UNITED STATES PATENT AND TRADEMARK OFFICE

APPLICATION NO.	FILING DATE	FIRST NAMED INVENTOR	ATTORNEY DOCKET NO.	CONFIRMATION NO.
10/682,183	10/09/2003	Faye Marshburn	031599/262714	7296
826	7590	07/06/2005	EXAMINER	
ALSTON & BIRD LLP BANK OF AMERICA PLAZA 101 SOUTH TRYON STREET, SUITE 4000 CHARLOTTE, NC 28280-4000			NGO, LIEN M	
			ART UNIT	PAPER NUMBER
			3727

Office Action Summary

FIG. 1

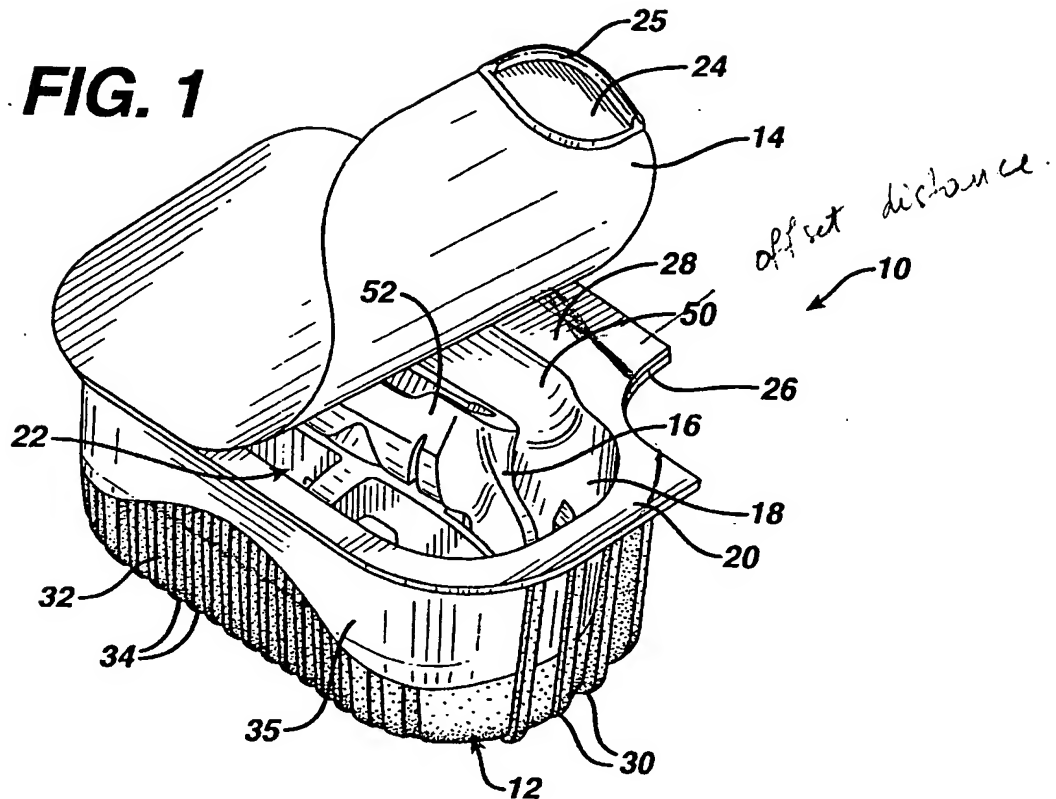
2. Claims 1-4, 7 and 9-14 are rejected under 35 U.S.C. 102(b) as being anticipated by Petricca (6,499,595). Petricca discloses, in figs. 1, and 12, a container comprising a flange having a substantially circular peripheral edge generally parallel to but radially offset by an offset distance (see fig. 1 of the attachment), a flexible membrane lid sealed to the outer surface of the flange by a seal having a portion reduced width located at a pull-tab portion 25 of the membrane lid. The membrane lid comprising a substrate and a layer of sealant (see fig. 12).
